Appendix A  
CORRESPONDENCE

Re: **Weinberger Subdivision**  
Village of Montebello  
LJA #03126

To: Village of Montebello Planning Board Members  
From: Eve Mancuso, P.E.  
✓ Re: Weinberger Subdivision  
Wetlands Review

TO: VILLAGE OF MONTEBELLO PLANNING BOARD  
FROM: ROBERT GENESLAW, AICP  
MAX STACH  
SUBJECT: WEINBERGER SUBDIVISION DEIS – SUBSTANTIVE REVIEW  
DATE: FEBRUARY 13, 2006  
CC: IRA EMANUEL , ESQ., PLANNING BOARD ATTORNEY  
EVE MANCUSO, P.E. VILLAGE ENGINEER  
CAROL ADDUCE, PLANNING AND ZONING CLERK

**UWNY - Figure 1**  
**Proposed Weinberger Subdivision**

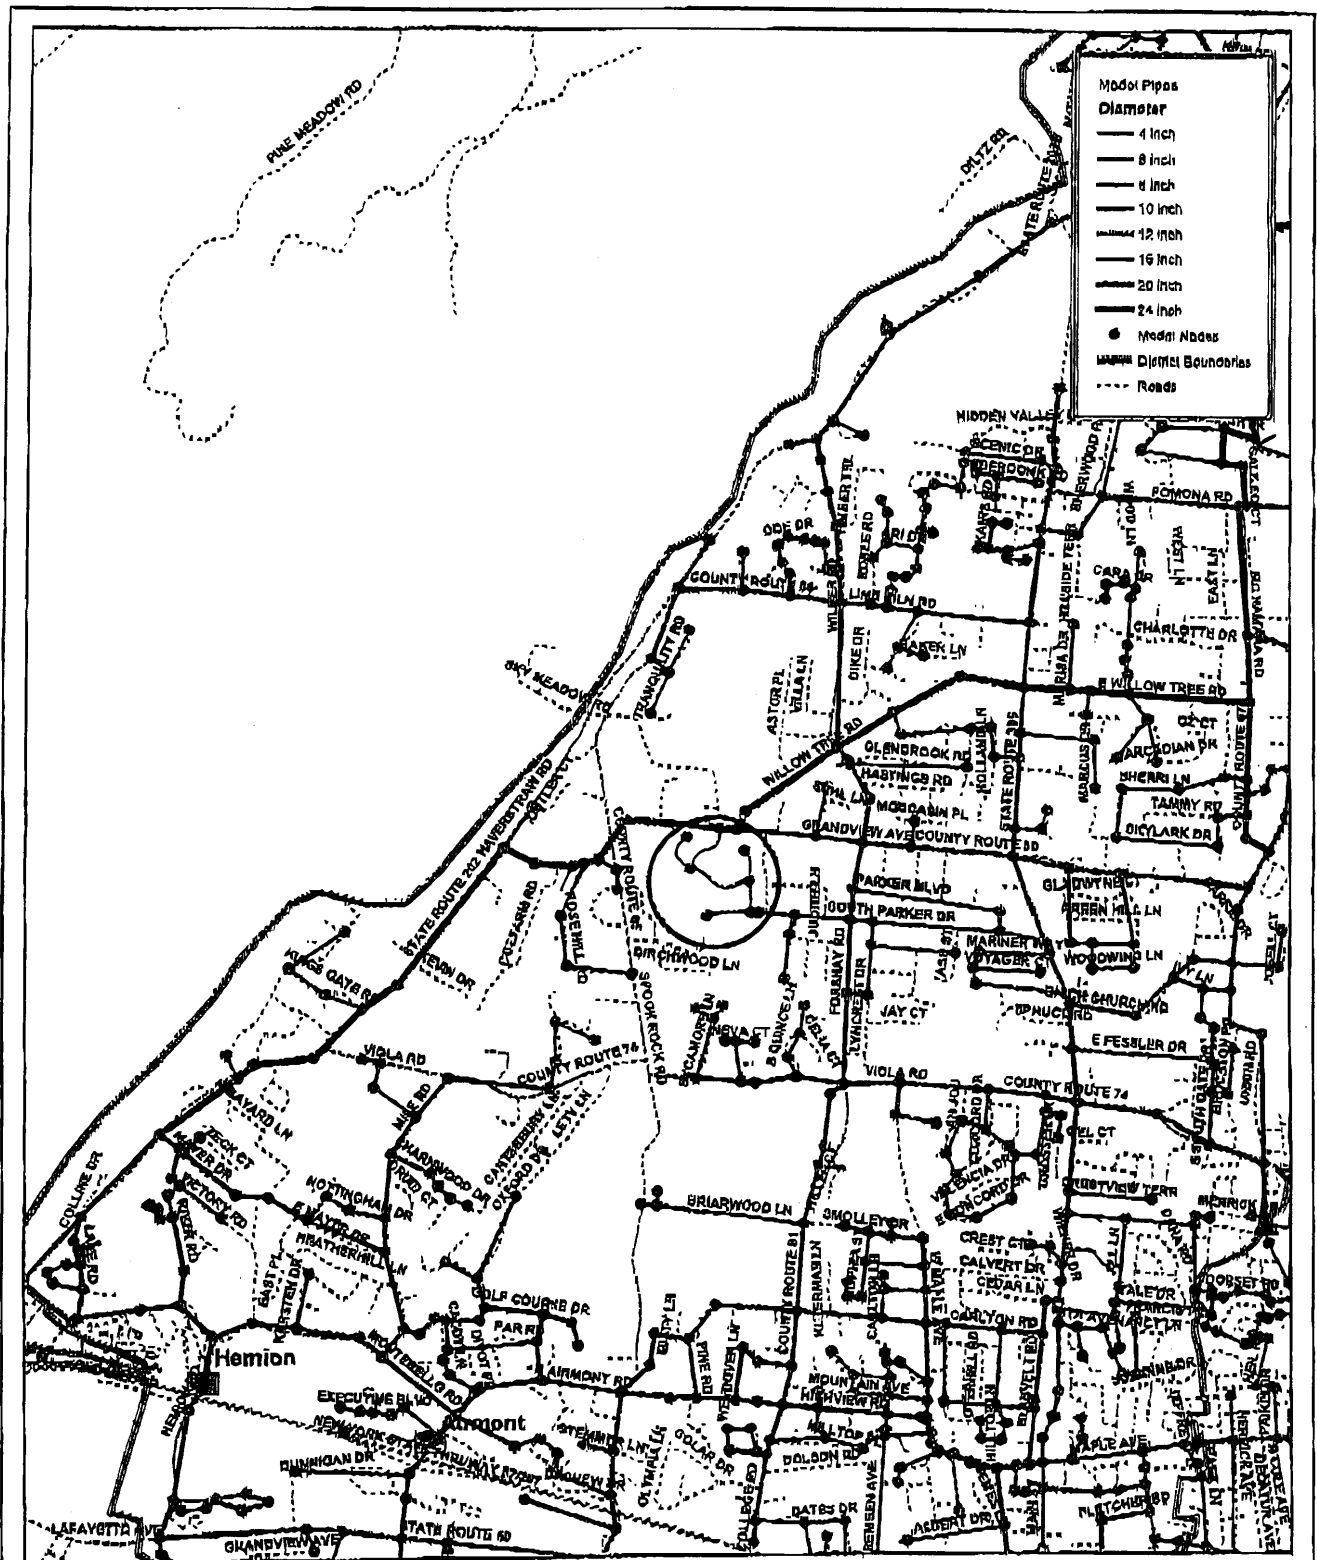
Service to the proposed housing development was simulated by adding pipes and demand nodes at the appropriate location in the existing UWNYS WaterGEMS water distribution system model. Figure 1 shows the configuration of the proposed development in the model.
